PUBLIC WORKS COMMITTEE MEETING
Monday March 20, 2023 at 4:30 p.m.
Caledonia Village Hall – 5043 Chester Lane

Re: Variance for Easement Encroachment - Vey Pool Project – 3268 Bergamot

VEY POOL PROJECT CALEDONIA, WI

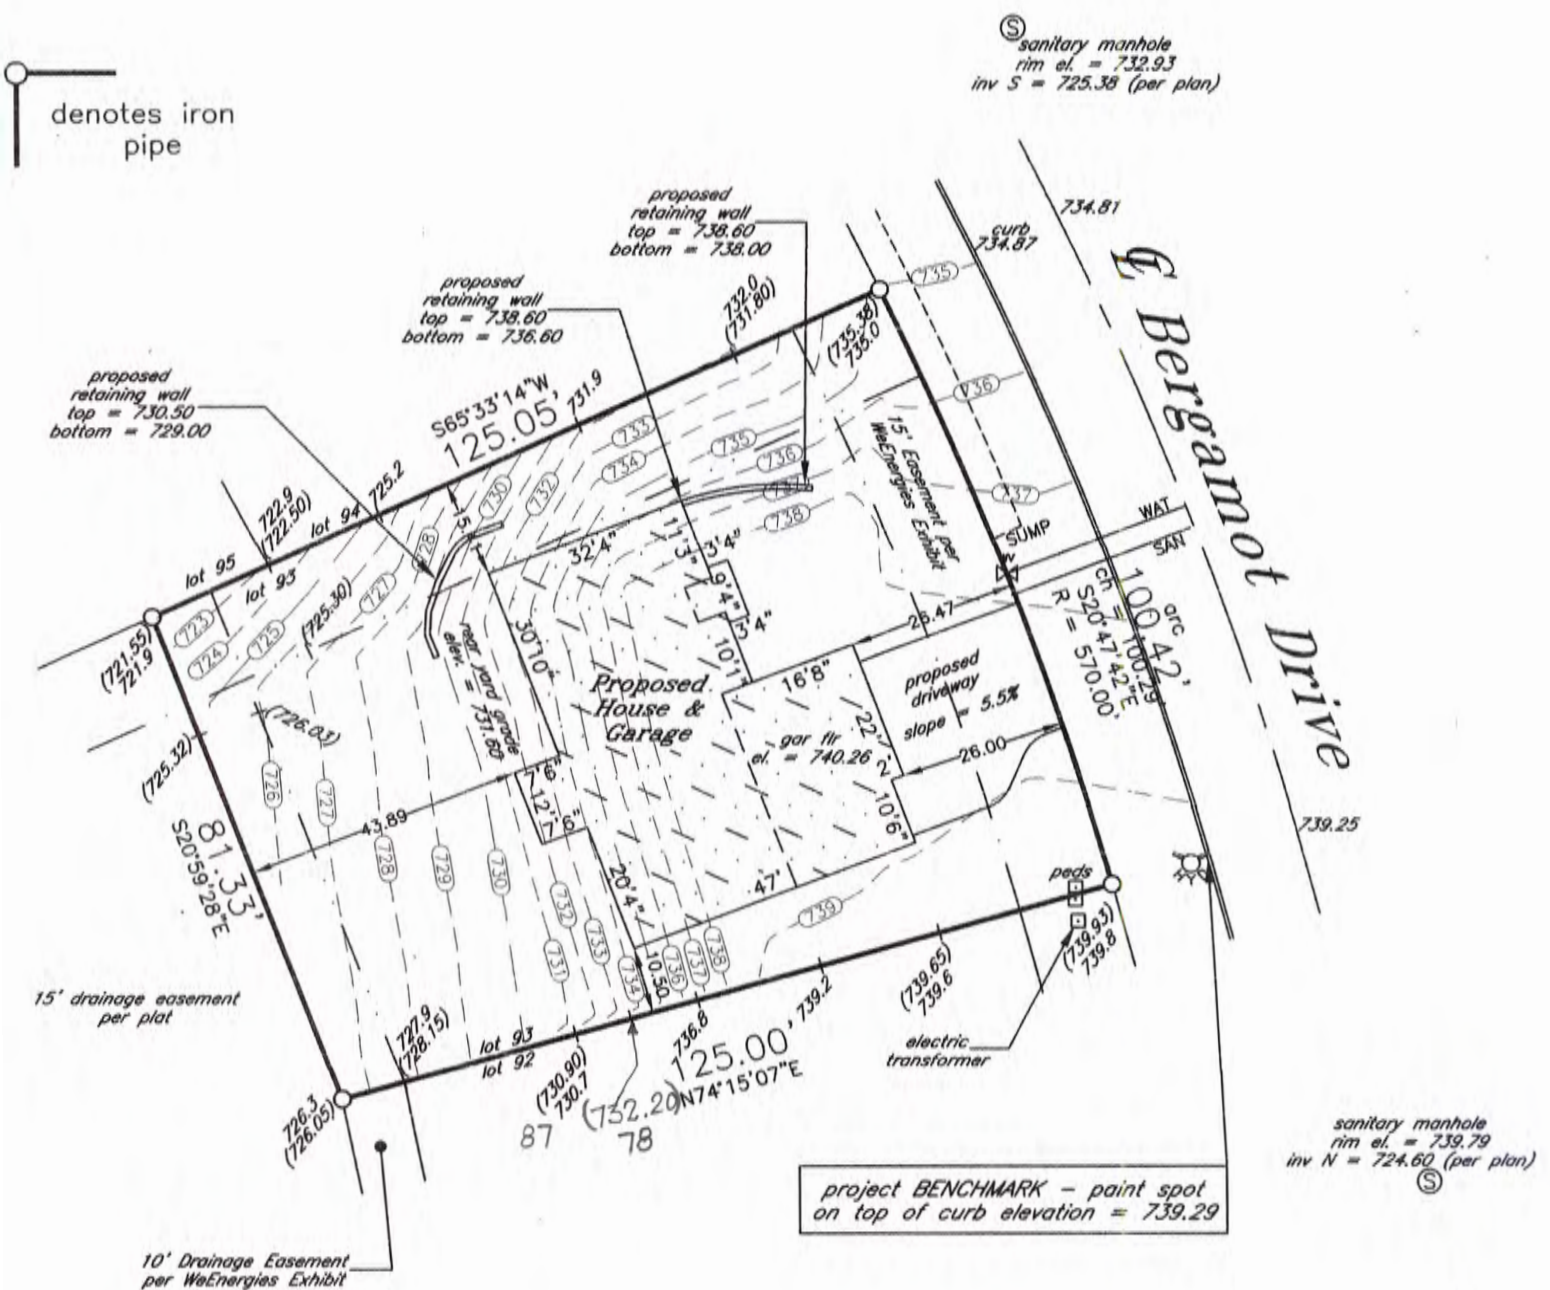
It appears we reached a roadblock after all the due diligence and would like to request a special "variance" meeting to allow a North wall retaining wall.

I discussed this wall with you over the phone a while back and the importance of our "walking safety" around the pool.

Please request a variance meeting with BPW to allow a retaining wall . I am not sure who you are requesting to be in attendance for this meeting.
